### **NEEDED UPDATES-AM1 Kirtright Pit**

# CONSTRUCTION MATERIALS REGULAR (112) OPERATION RECLAMATION PERMIT APPLICATION FORM

LARIMER COUNTY, CO COULSON EXCAVATING CO, INC **EXHIBIT C-1**

### 6.4.1 Exhibit A – Legal Description

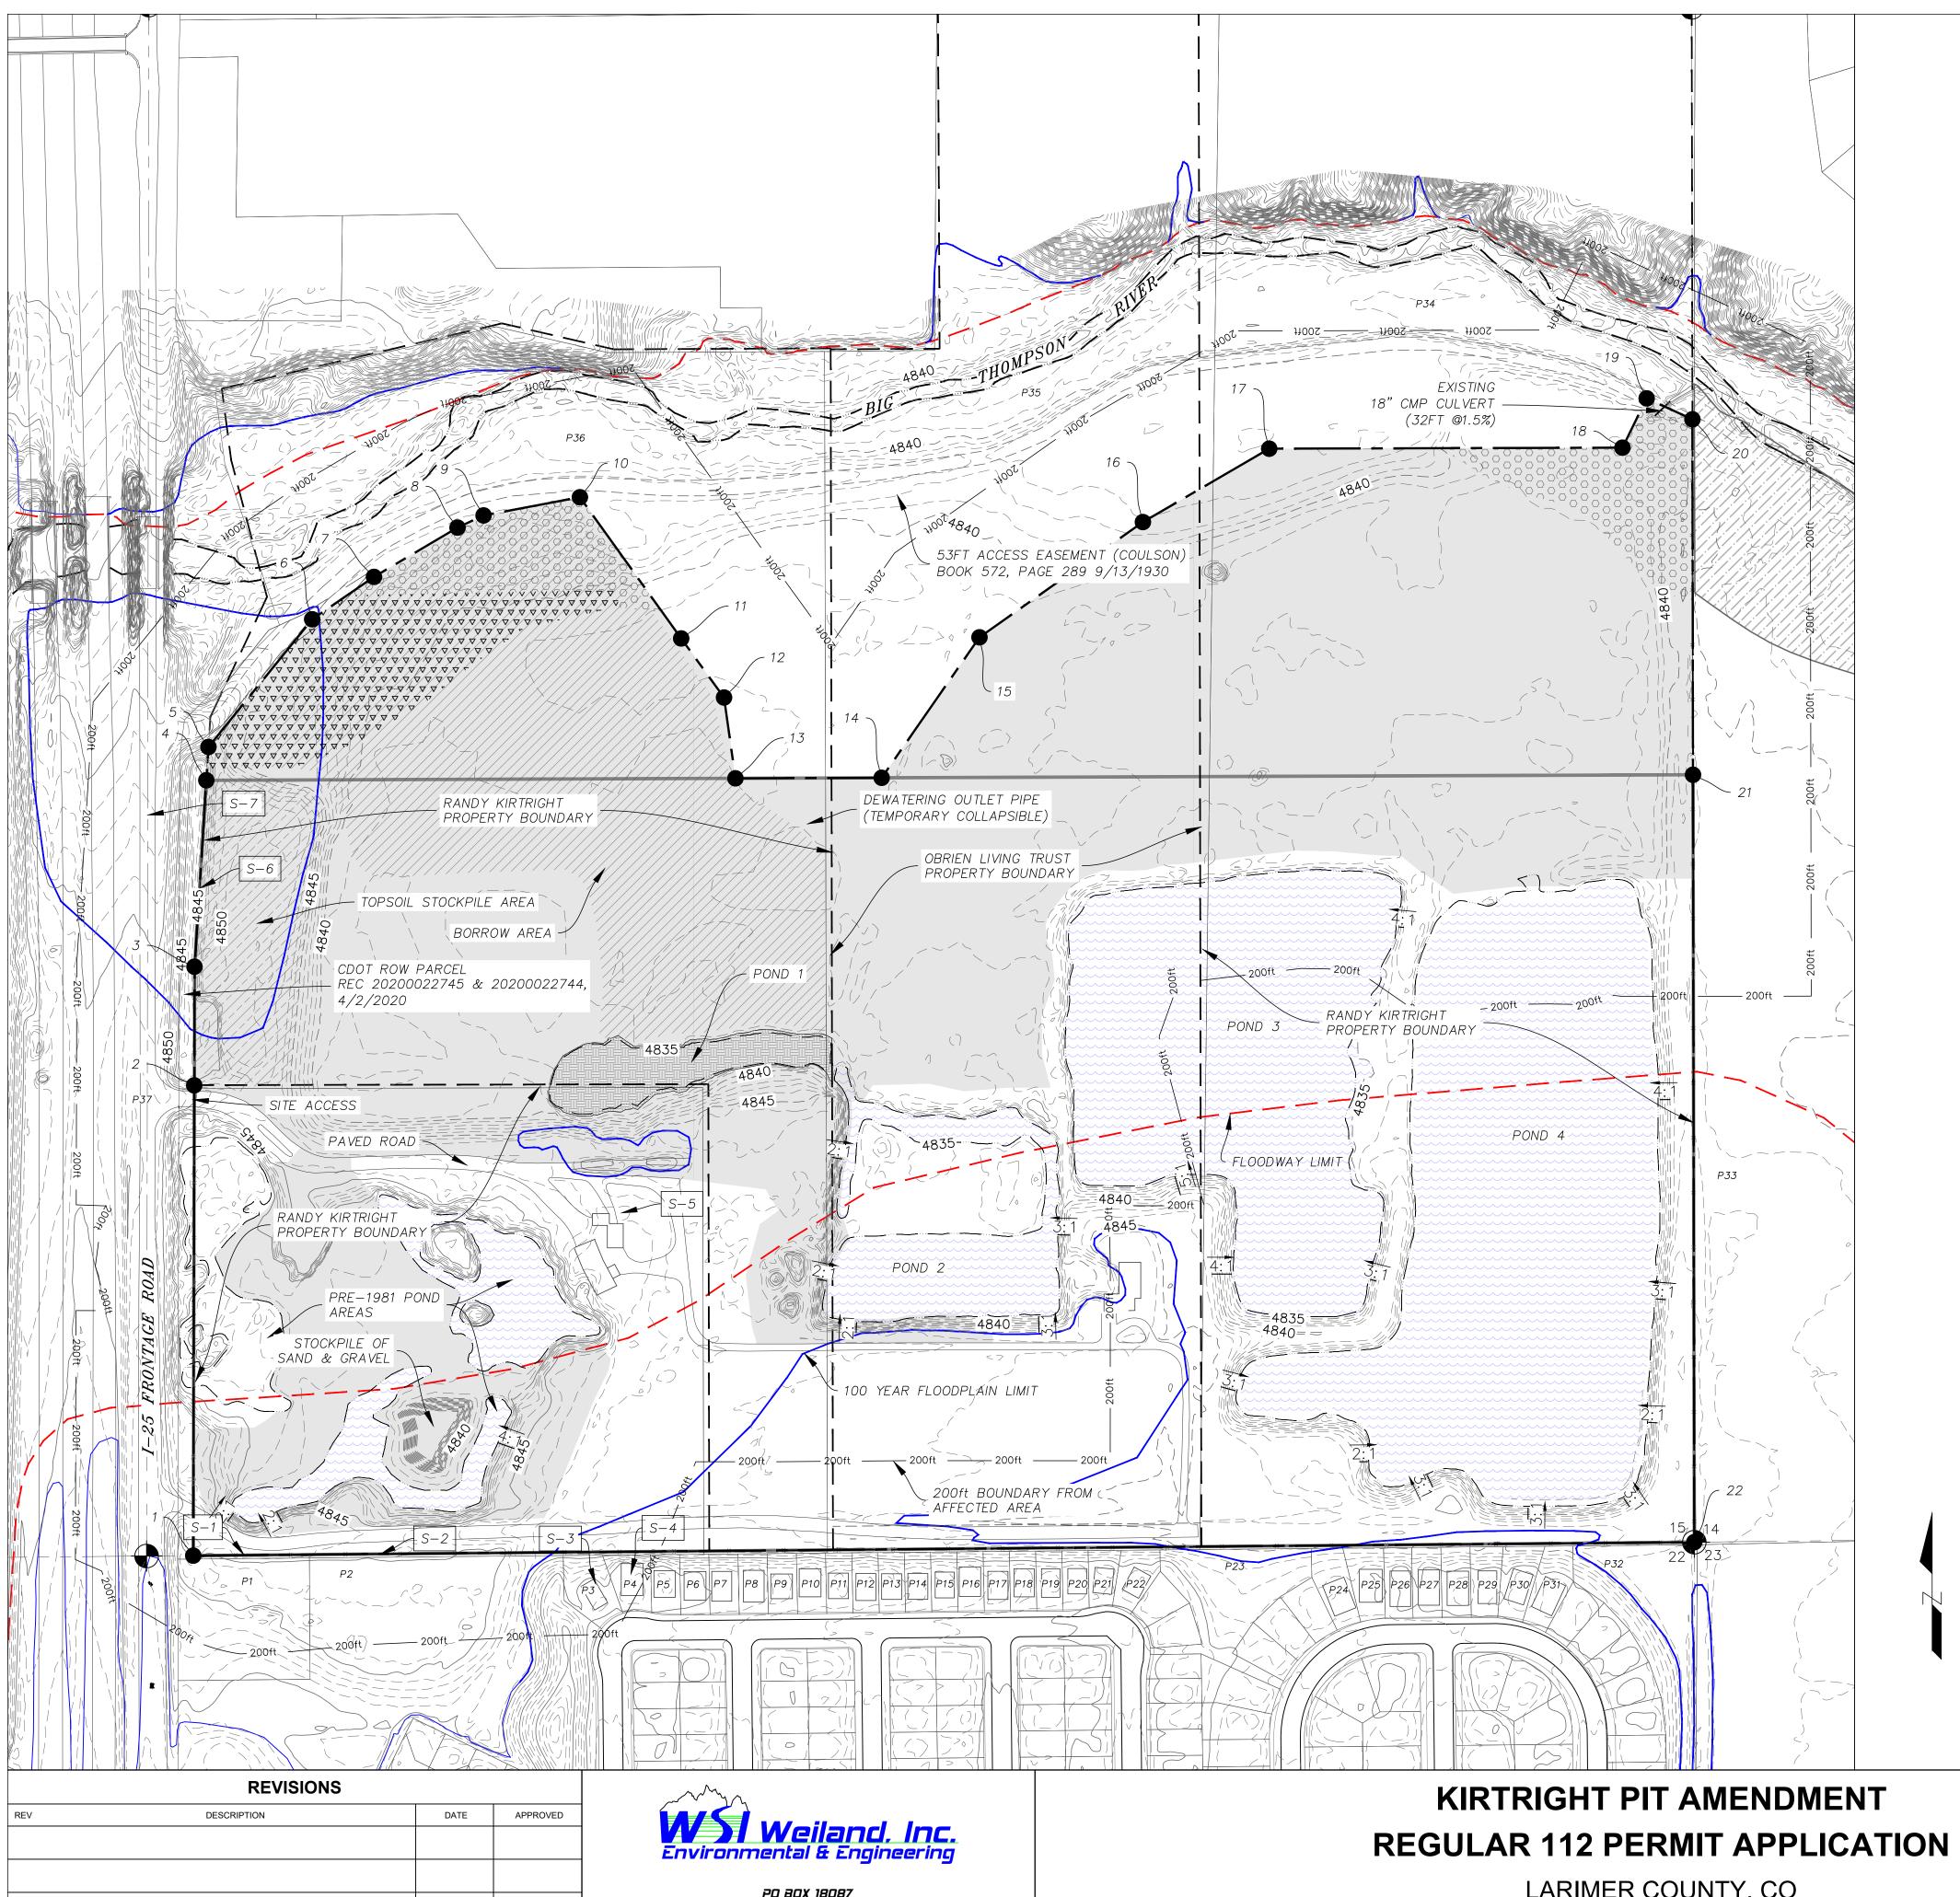
4-Exhibit A is missing the mine entrance coordinates.

The mine entrance is located at the following UTM NAD83 (2011), Zone 13 (meter) coordinates: Northing: 4,471,568.922(m), Easting: 500,609.041(m)
